Staff Report & Recommendation

Historic Preservation Board

SUBJECT: HPB25-0656, **1600 Washington Avenue**

An application has been filed requesting a Certificate of Appropriateness for the total demolition of two structures and the construction of a new mixed-use building.

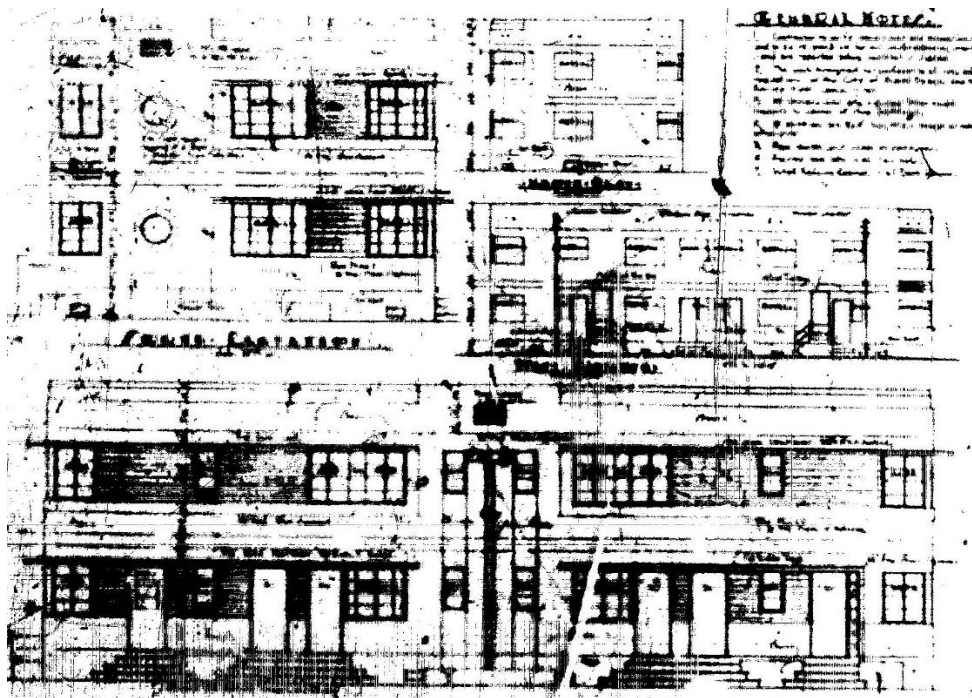
The subject development site contains three existing structures:

1. 1600 Washington Avenue: A 1-story 'Non-Contributing' commercial building.
2. 425 16th Street: A 2-story multifamily residential building, classified as 'Contributing'.
3. 1601 Drexel Avenue: A recently constructed 5-story 'Non-Contributing' parking garage with accessory commercial use.

The project includes the total demolition of the existing 1-story Non-Contributing building located at 1600 Washington Avenue as well as the total demolition of the existing 2-story Contributing building and the construction of a new 15-story ground level addition containing 210 residential units and approximately 7,000 SF of retail space on the ground floor. The existing parking garage will be retained and incorporated into the new mixed-use development.
